Cobbora Solar Farm – Environmental Impact Statement

Thank you for your request via the NSW Major Projects Planning Portal dated 29 August 2025 to the Conservation Programs, Heritage and Regulation Group (CPHR) of the NSW Department of Climate Change, Energy, the Environment and Water (NSW DCCEE) inviting comments on the Environmental Impact Statement (EIS) for the Cobbora Solar Farm.

CPHR has reviewed the EIS and Biodiversity Development Assessment Report (BDAR) and consider that the BDAR is likely to underestimate the biodiversity impacts of the proposal and is not compliant with the Biodiversity Assessment Method (BAM).

Figure 1 – Examples of areas of Category 2 – Vulnerable Regulated land and woody vegetation (green polygons) mapped as Category 1 – Exempt in the project land category assessment

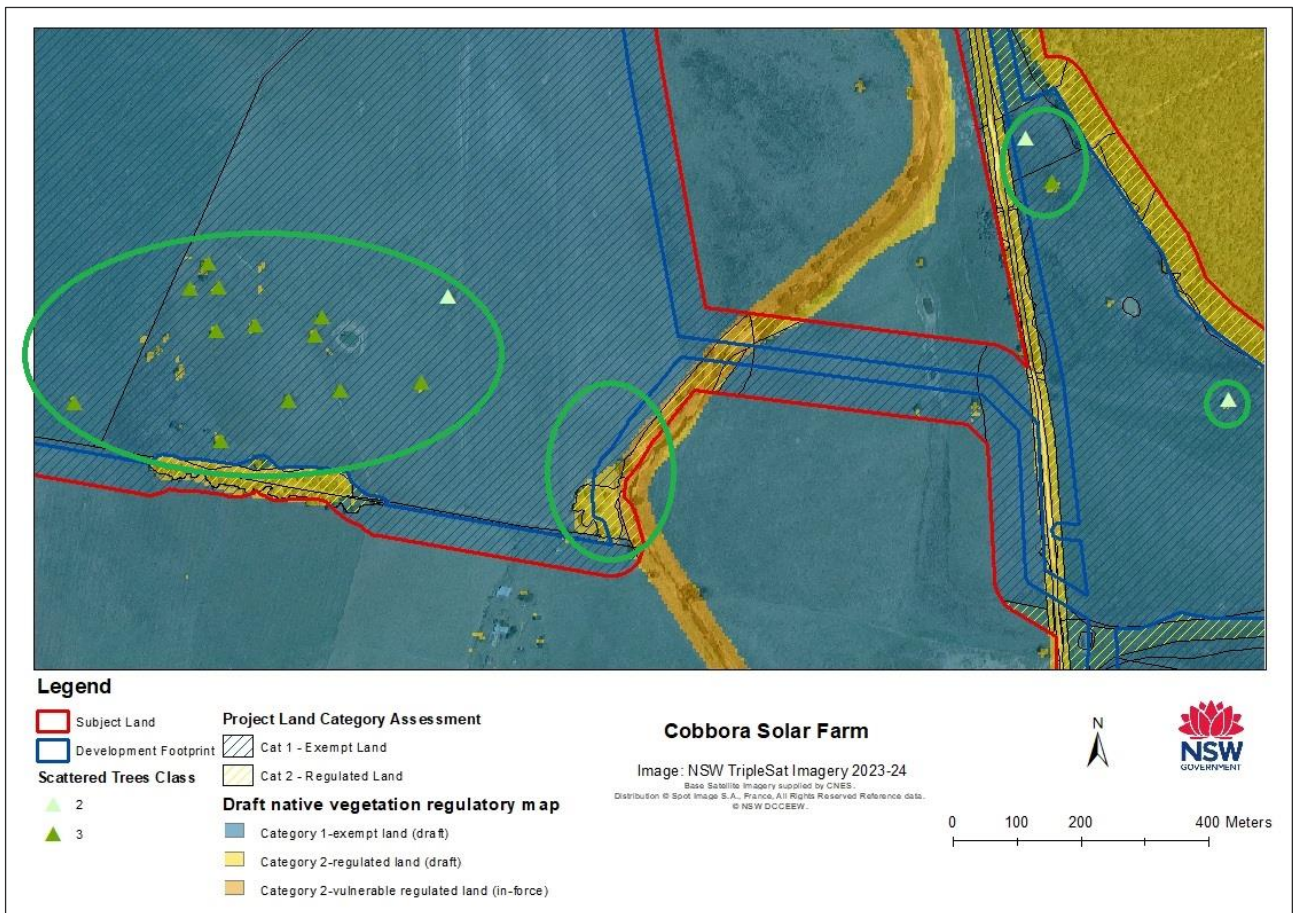
The draft NVR map shows parts of the study area which meets Category 2 – Regulated land criteria in accordance with the NVR Map Method Statement,² however some of the Category 2-Regulated land on the draft NVR map has been mapped as Category 1 – Exempt land in the land categorisation assessment (see **Figure 1**).

The subject land also contains land mapped as Category 2 – Vulnerable Regulated land on the draft NVR map, which cannot be re-categorised as Category 1 – Exempt land. We understand that small areas of Category 2 – Vulnerable Regulated land along the boundaries of watercourses have been recategorized as Category 1 – Exempt Land (see **Figure 1**). The land categorisation for these areas should be revised to ensure any areas of Category 2 – Vulnerable Regulated land is retained and assessed in accordance with the BAM.

- 1.1 Review the land categorisation assessment against the final determination for Box Gum Woodland CEEC and provide justification and evidence that areas mapped as Category 1 – Exempt land are not Box Gum Woodland CEEC.
 - 1.2 Reinstate all Category 2 – Regulated land as mapped on the draft NVR map or seek a formal map review.
 - 1.3 Ensure any areas of Category 2 – Vulnerable Regulated land mapped in the subject land are retained and assessed in accordance with the BAM.
 - 1.4 Update the BDAR and BAM-C to reflect any changes made to the land categorisation assessment.
2. Review the vegetation mapping and ensure all native vegetation has been assigned to a vegetation zone or streamlined assessment module.

Figure 2 – Examples of woody vegetation which has a duplicated credit obligation (orange polygon), may be suitable to include in a nearby vegetation zone (purple polygon), or not been assessed at all (blue polygon)

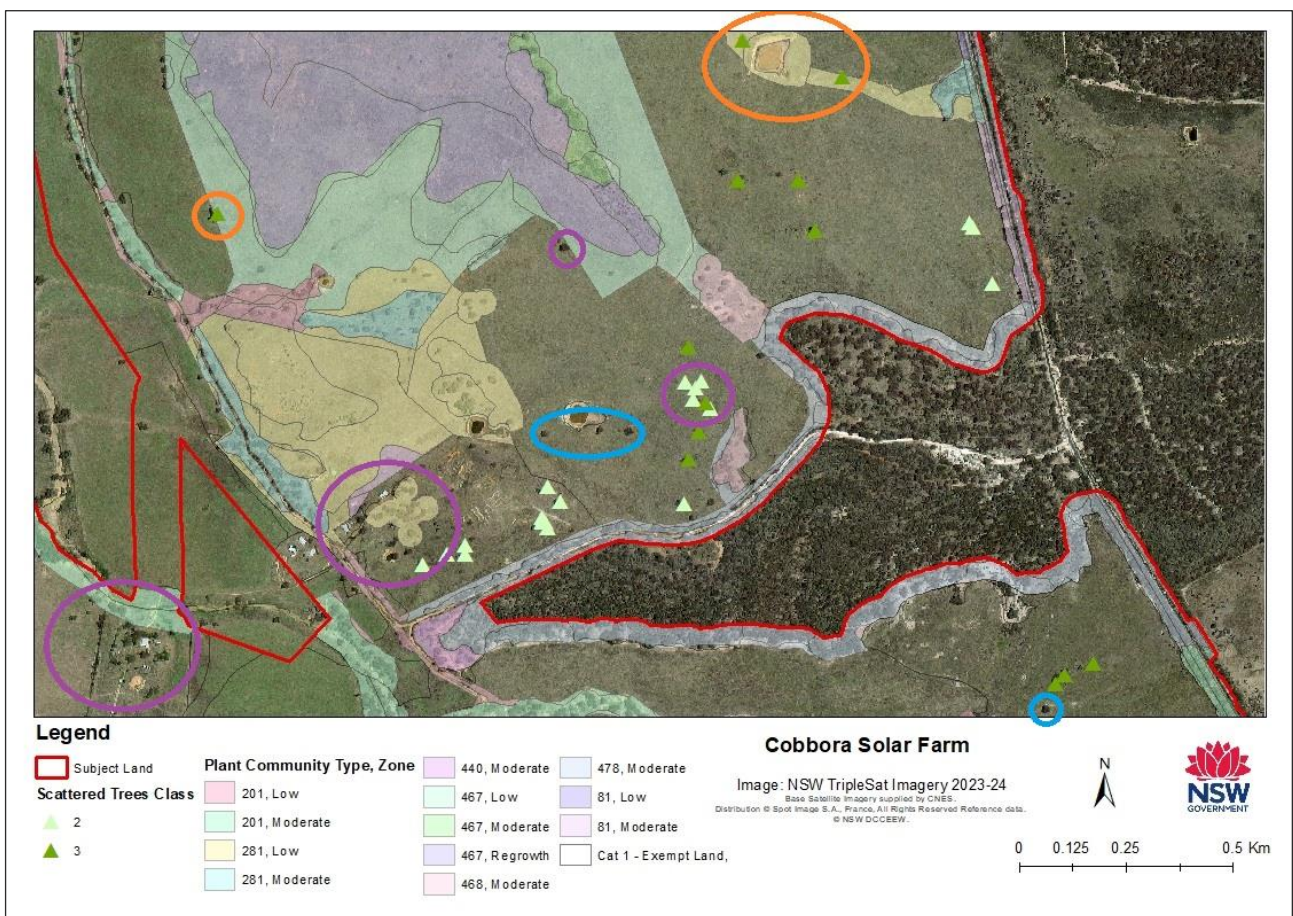
CPHR has reviewed the BDAR against the spatial data package and note that some patches of vegetation have not been included in any vegetation zones or the scattered tree module. The purple polygons in **Figure 2** below show areas of woody vegetation in the subject land which has not been included in any vegetation zones.

Section 3.3.4 of the BDAR indicates that part of the subject land is assessed under the BAM streamlined assessment module – scattered trees. Spatial data indicates that there are some areas where scattered trees have not been assessed (blue polygons in **Figure 2**) and some areas where

scattered trees have been included in vegetation zones in one BAM-C case and duplicated in the streamlined assessment module BAM-C case (orange polygons).

All native vegetation should be assigned to a vegetation zone or the scattered tree assessment module in the spatial data and BAM-C. The BAM-C cases should also be reviewed to ensure that there is no duplication of scattered trees across both BAM-C cases.

- 2.1 Conduct a full audit of the spatial data to ensure all native vegetation is assigned to a vegetation zone or the scattered tree streamlined assessment module.
- 2.2 Review both BAM-C cases and ensure that a credit obligation has not been duplicated for trees assessed under the scattered tree module.

Figure 3– Pine donkey orchids detected within the project and species polygon (100m buffer)

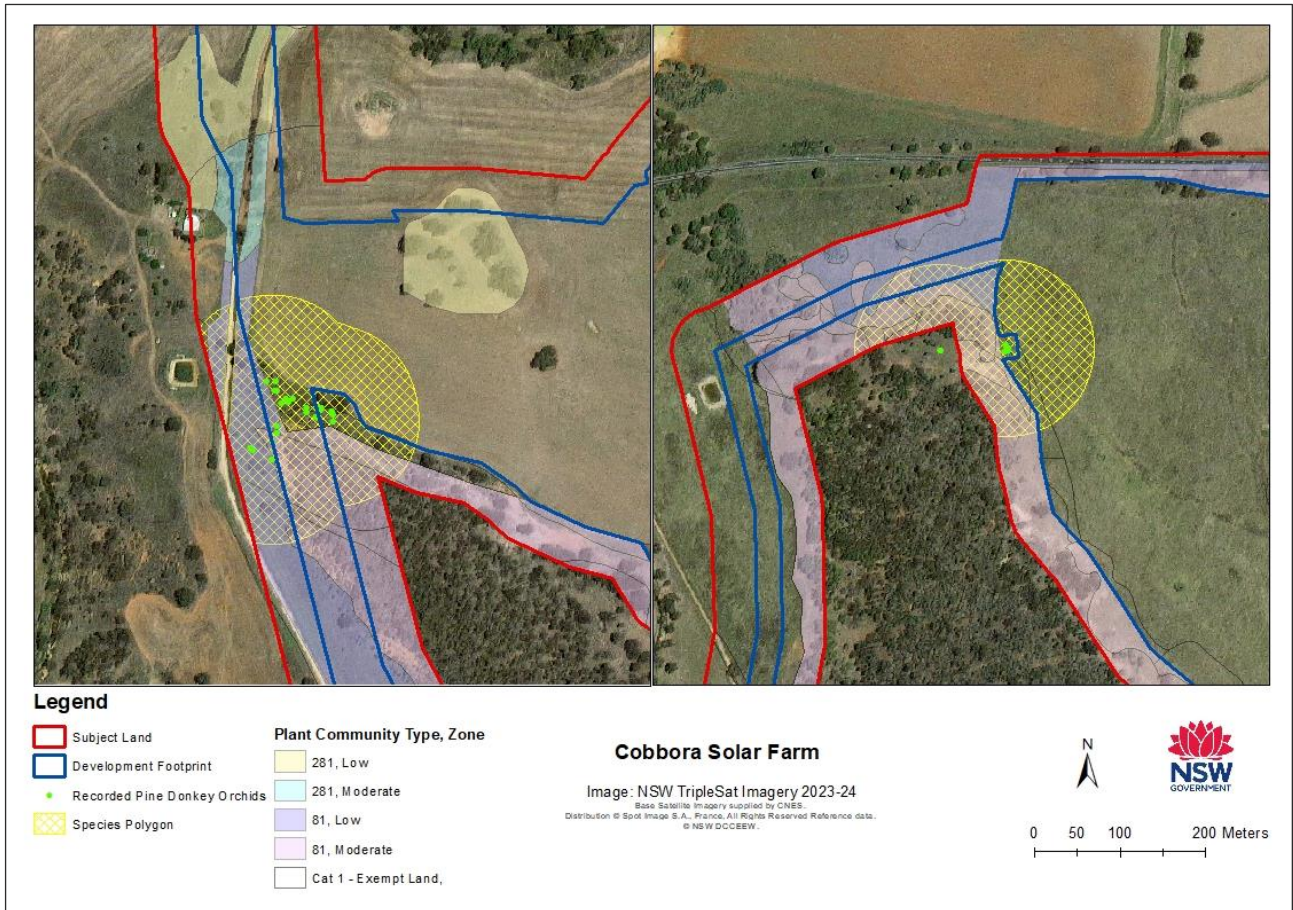
Two populations of pine donkey orchid have been recorded within the development footprint. The BDAR does not contain sufficient ecological justification for the delineation of the species polygon, aside from the application of a 100m buffer around recorded individuals (**Figure 3**).

As per the Threatened Biodiversity Data Collection (TBDC), pine donkey orchids are assessed by “*area of suitable habitat*”. For species assessed by area of suitable habitat, the species polygon should encompass all detected individuals and all suitable habitat on the subject land (s.5.2.5 of the BAM and s.4.4.5 of the BAM Operational Manual Stage 1). Where associated PCTs or vegetation zones are excluded from the polygon, provide clear justification for their exclusion and justify the use of the 100m buffer. Alternatively, the species polygon should be revised to include all suitable habitat.

8.1. Provide an ecological justification for the buffer applied to pine donkey orchid populations, or, revise the species polygon to be inclusive of all suitable habitat.

Figure 4 – Areas where targeted survey for threatened flora species has not been conducted (blue polygons)

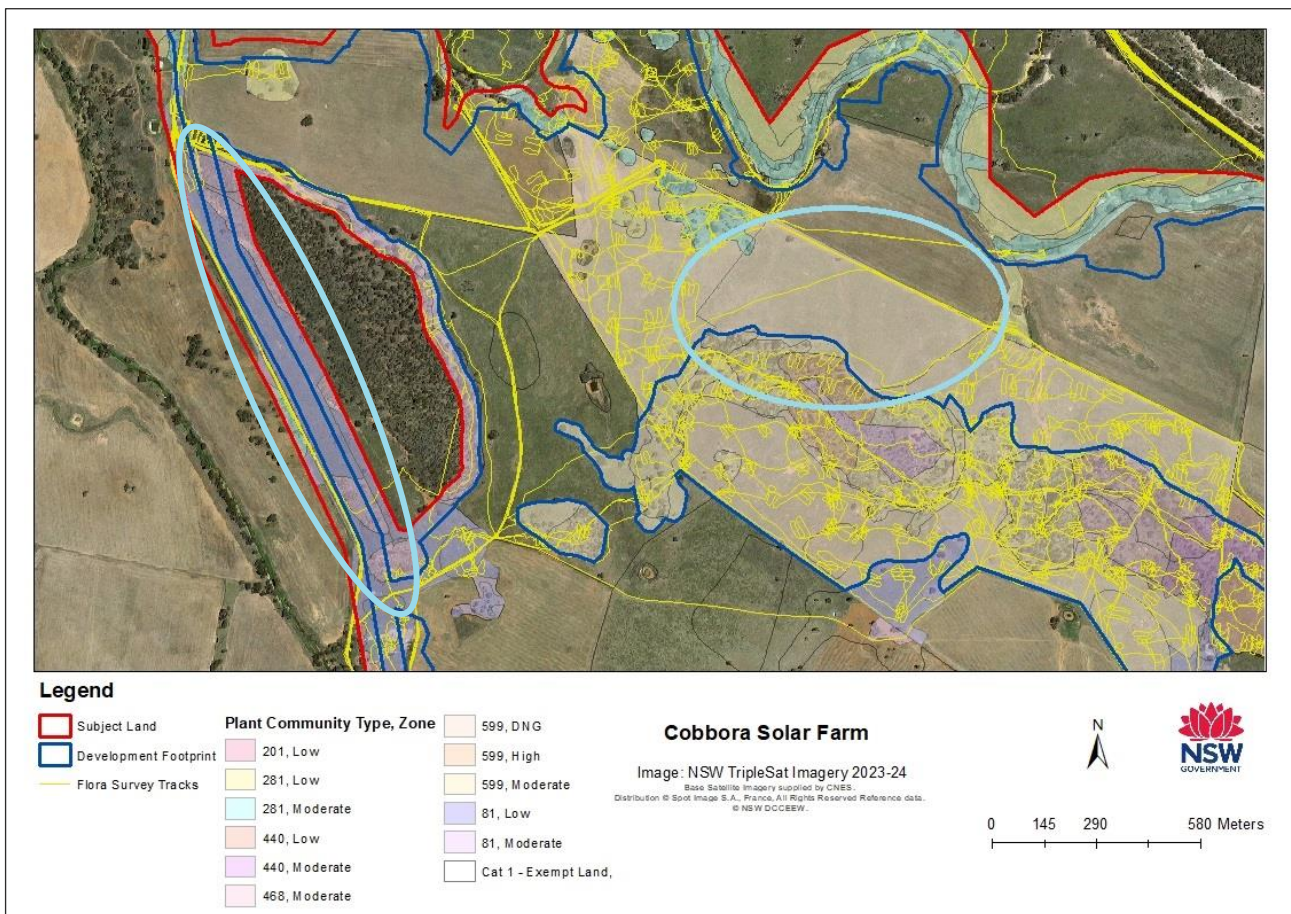
Generally, the coverage of species-specific survey effort is sufficient, however, two notable areas do not appear to have been surveyed (**Figure 4**). This includes:

- A proposed access road intersecting through approximately 9 hectares of PCT 81. This area is immediately to the south of a detected population of pine donkey orchid.
- A portion of the proposed southern solar panel array comprising approximately 19 hectares of PCT 599.

Demonstrate the targeted survey effort for candidate threatened flora species was sufficient, particularly in the areas identified above. If suitable habitat for threatened flora is present in these areas, conduct targeted survey, assume presence or obtain an expert report, in accordance with section 5 of the BAM.

- 10.1. Provide justification of the survey effort for threatened flora, specifically addressing the areas identified in this response. Where suitable habitat is present, undertake further targeted surveys, prepare an expert report, or assume presence for relevant candidate flora.
11. Further justification is required for candidate threatened flora species excluded based on degraded habitat

Figure 8 – Subset of targeted fauna species survey which shows survey efforts have not occurred within the development footprint

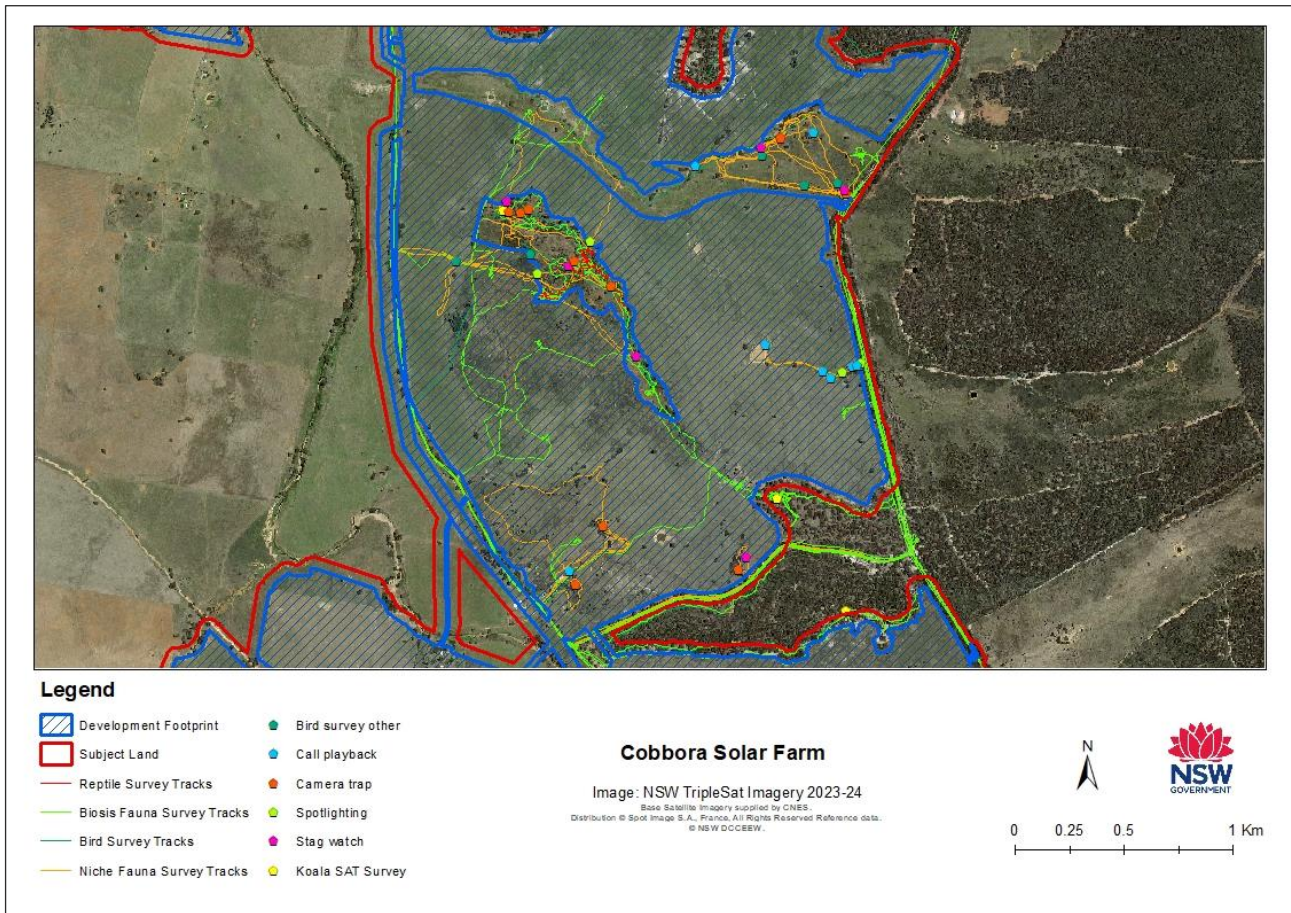
The survey effort for several species has occurred in areas outside of the proposed development (e.g for pink-tailed legless lizard, see **Figure 8**) despite the presence of suitable habitat within the proposed footprint.

CPHR does not support the use of targeted surveys completed in areas of indirect impact as a surrogate for determining species presence or absence within the development footprint.

If the development footprint contains suitable habitat, conduct additional targeted surveys for threatened fauna species in accordance with threatened species survey guidelines. Alternatively, assume presence or obtain an expert report in accordance with section 5.2 of the BAM.

13.1. Conduct targeted surveys for species credit fauna species with suitable habitat in the development footprint, or assume presence or obtain an expert report, in accordance with section 5.2 of the BAM.
